# FINAL DRAFT MINUTES

## October 21, 2021 Standards Committee Meeting

RE: Minutes from the October 21, 2021 Standards Committee Meeting

PROBLEM(S) ENCOUNTERED: The Standard Drawing series for flagger operations (E 801-TCFO) largely date back to 1997 and include details for work that does not include flagging. INDOT Standard Drawings E 801-TCFO-03, E 801-TCTC-09, and E 801-TCTC-10 depict mobile operations and should be combined into a new series just for mobile operations. Other sheets in the temporary closure series (801-TCTC) are duplicates of other drawings or show information that should be detailed in the plans.

E 801-TCFO-01 FLAGGER OPERATIONS (WITH MARKUPS)

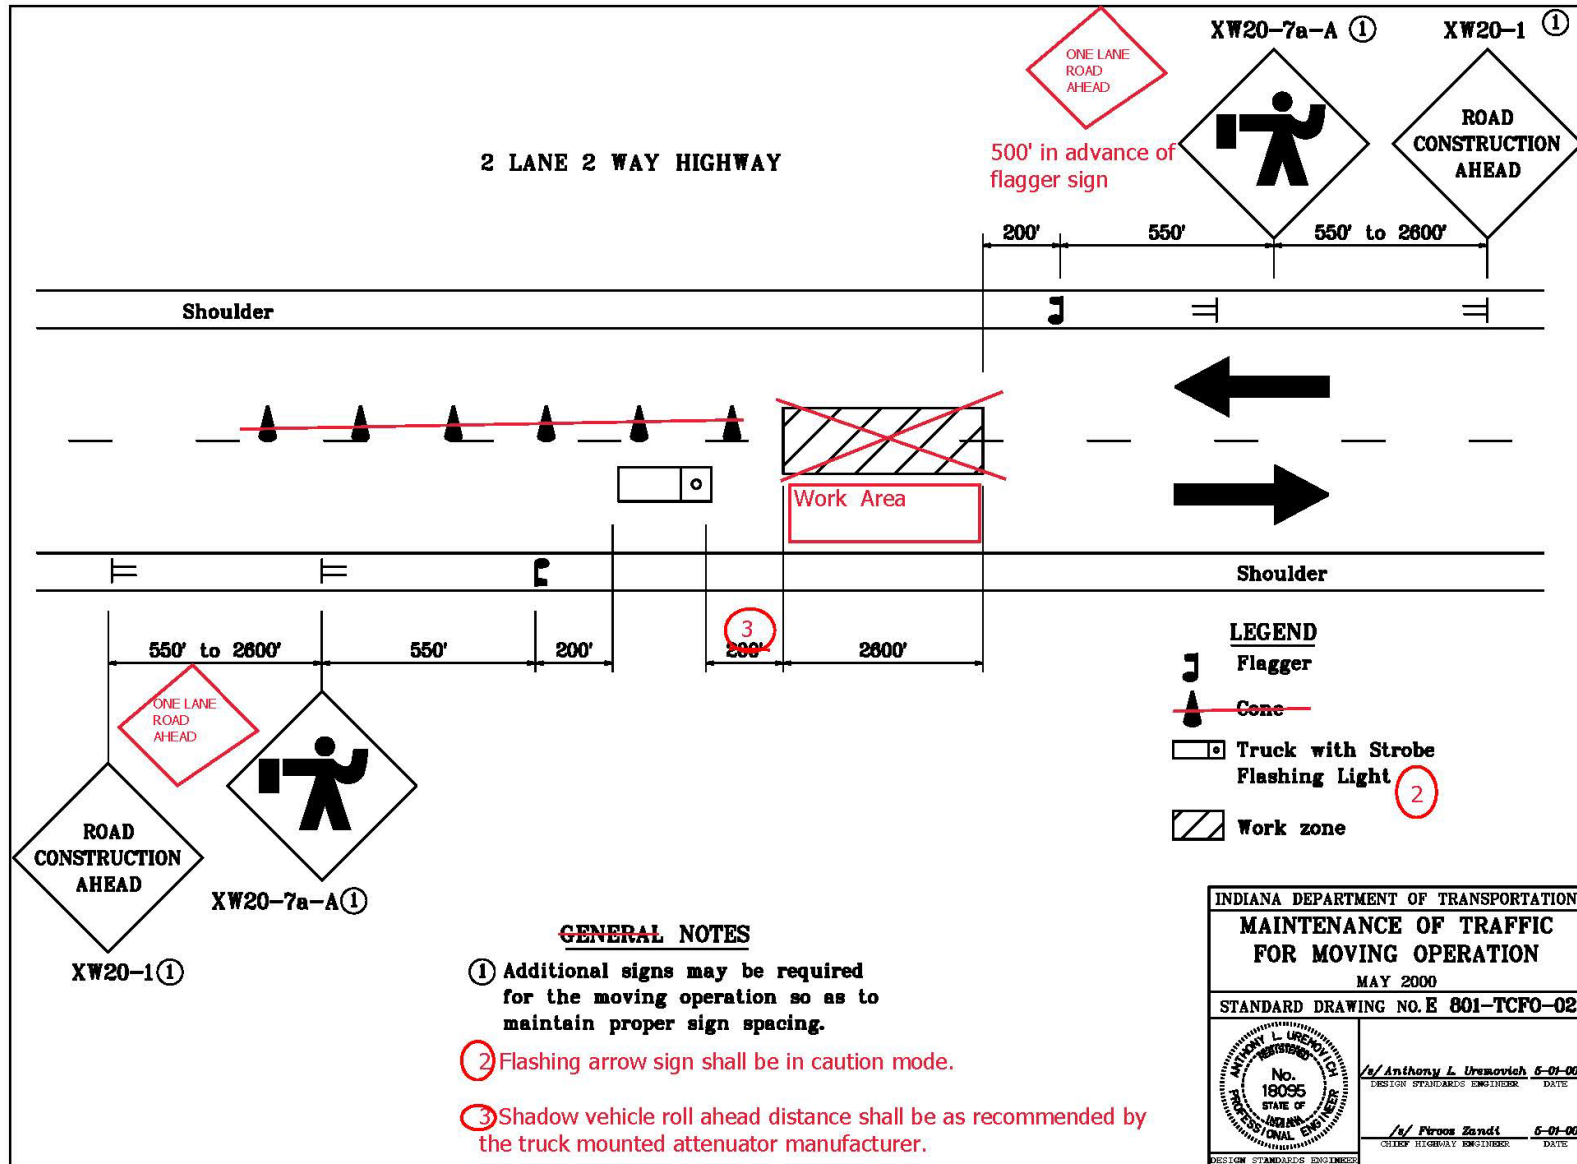
PROPOSED SOLUTION: Revise and update the standard drawing series on flagger operations (E 801-TCFO) and create a new series for mobile operations (E 801-TCMO). Delete unnecessary and duplicate details from the temporary closure series (E 801-TCTC).

E 801-TCFO-05 TRAFFIC CONTROL FOR OVERHEAD INSTALLATION (WITH MARKUPS)

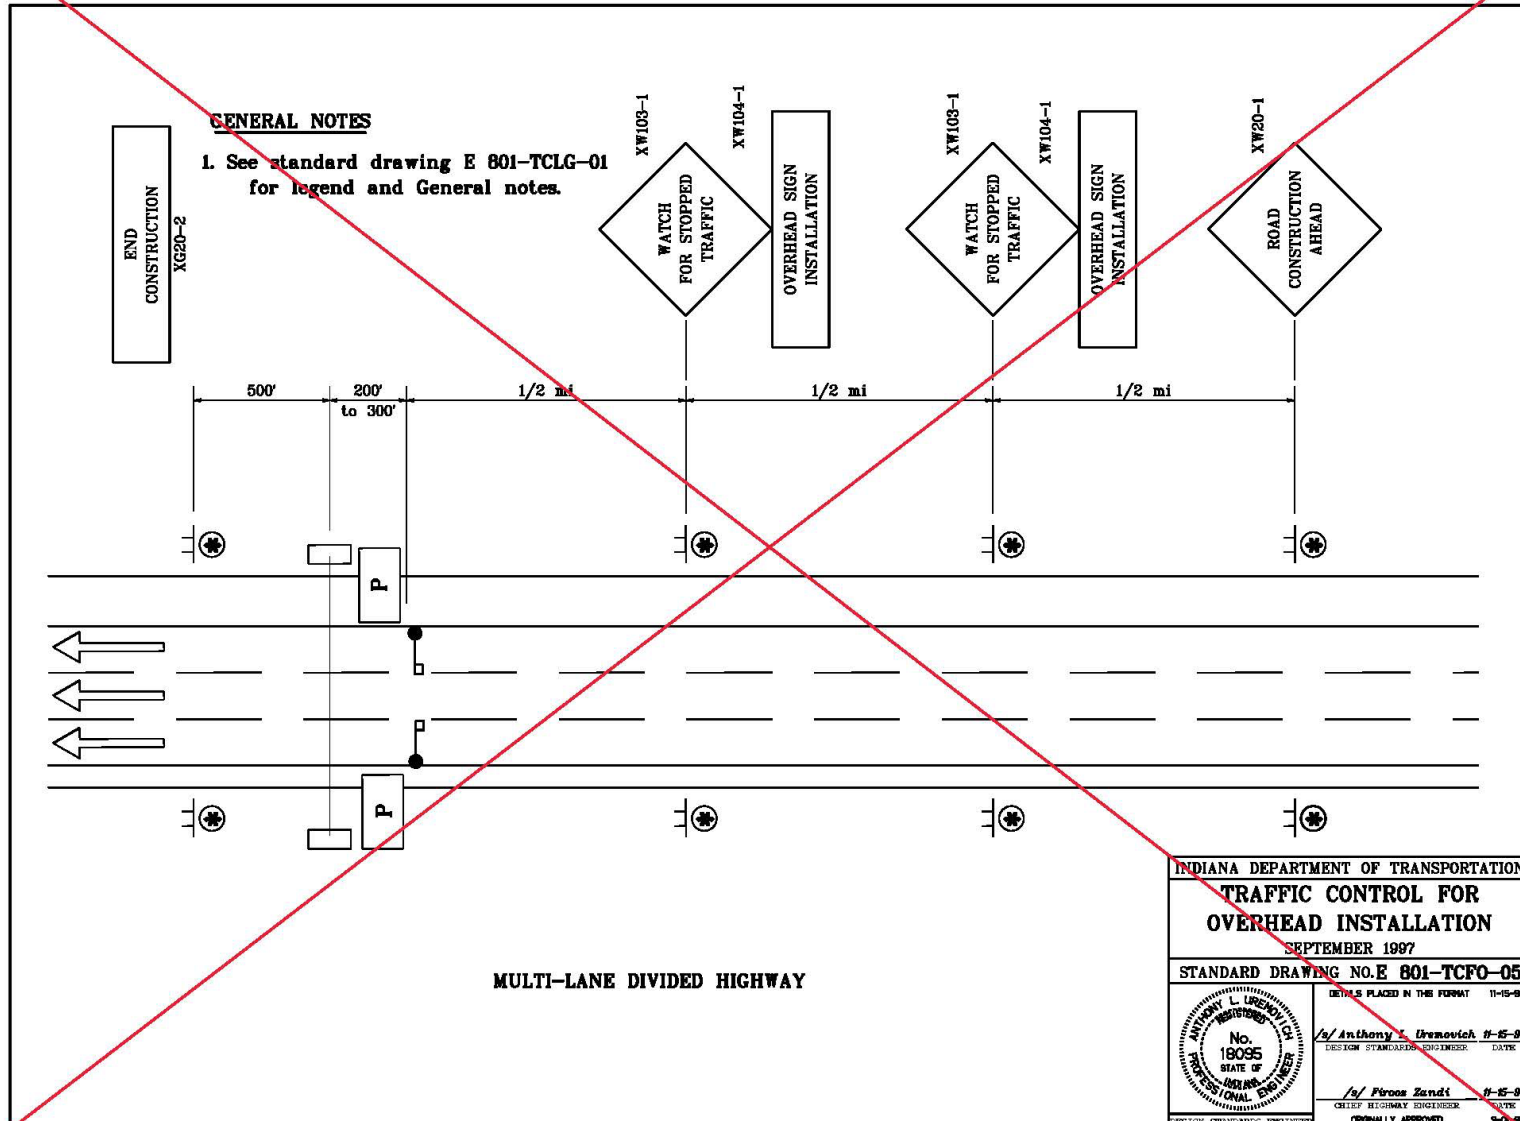
DELETE

E 801-TCTC-05 TRAFFIC CONTROL FOR DAYTIME LANE CLOSURE (WITH MARKUPS)

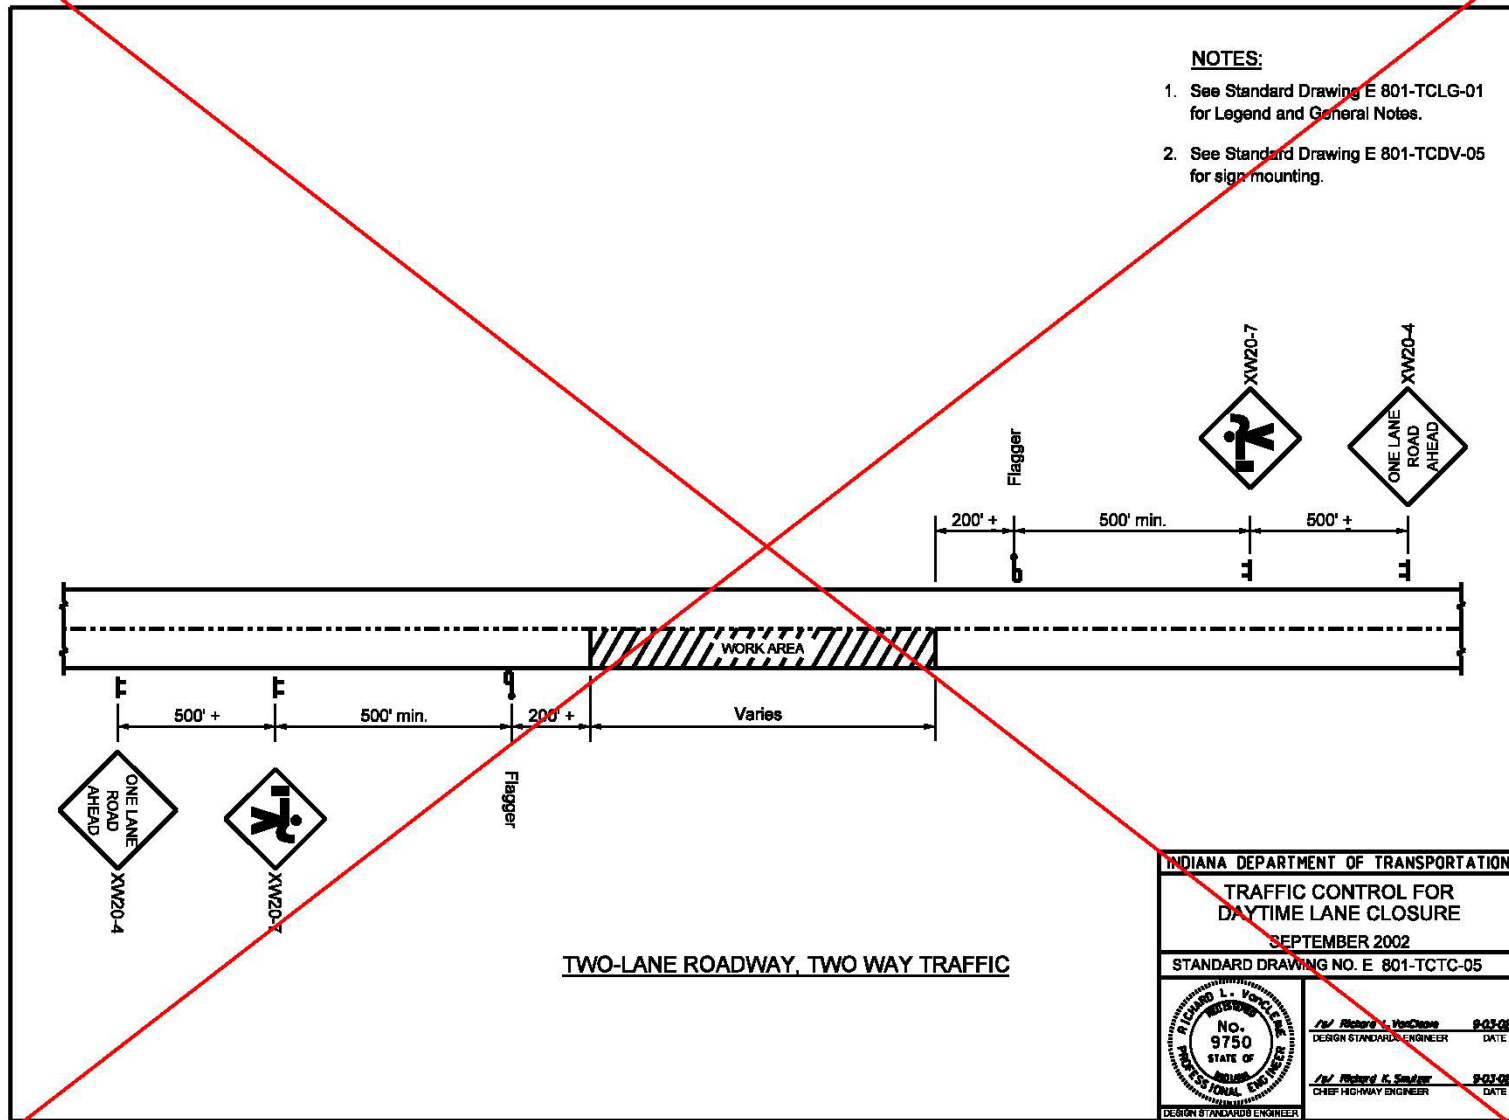
Delete (Addressed in 801-TCFO Series)

E 801-TCTC-06 MAINTENANCE OF TRAFFIC FOR RPM CASTING INSTALLATION (WITH MARKUPS)

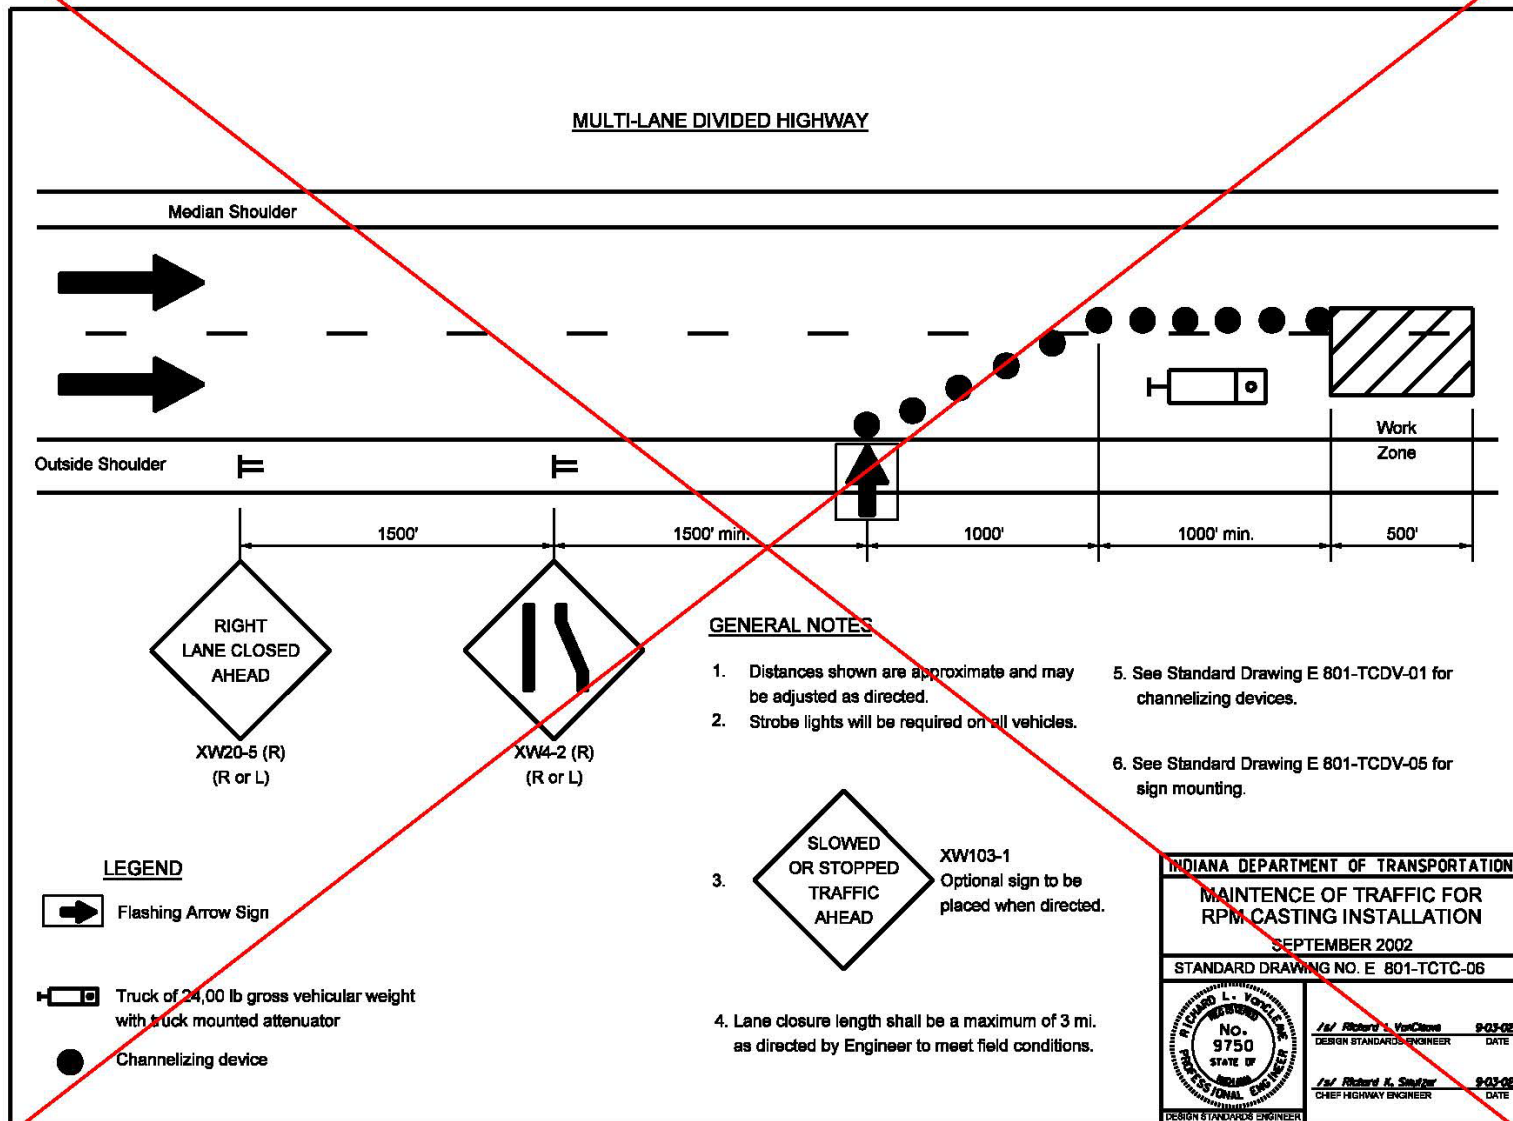
(Duplicate of 801-TCFO-03)

E 801-TCTC-07 MAINTENANCE OF TRAFFIC FOR RPM CASTING REPLACEMENT (WITH MARKUPS)

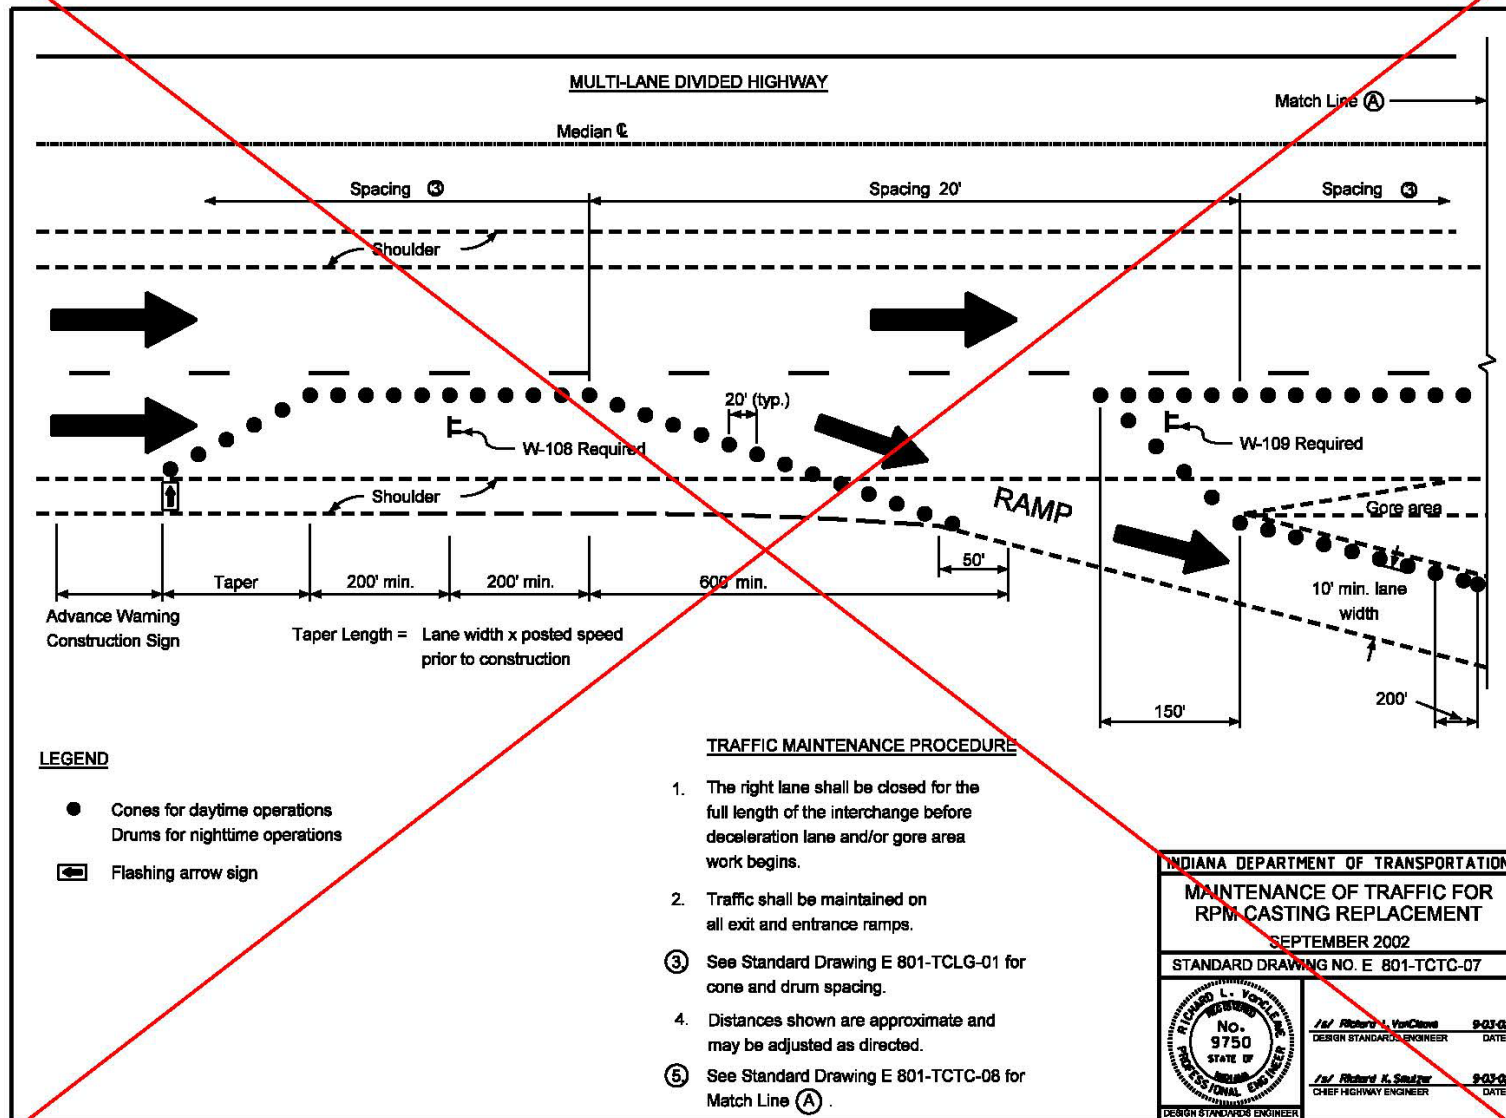
(Addressed in 801-TCLC-15)

E 801-TCTC-09 MAINTENANCE OF TRAFFIC FOR RPM REFLECTOR REPLACEMENT (WITH MARKUPS)

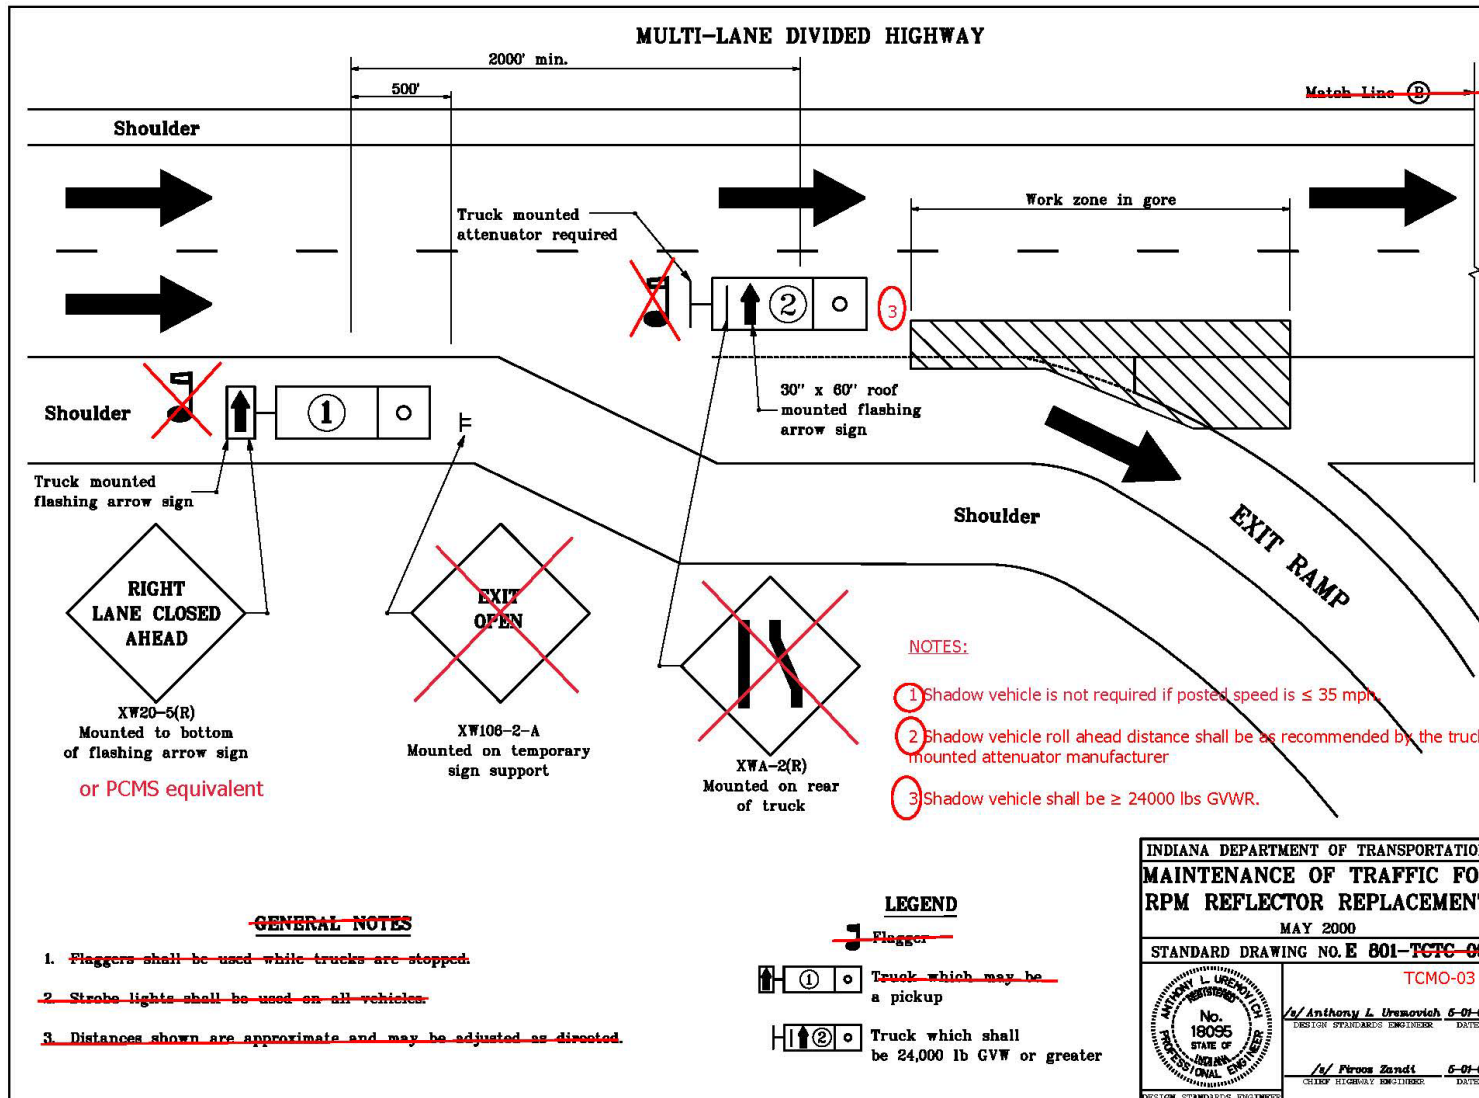
Move to New Series on Traffic Control for Mobile Operations
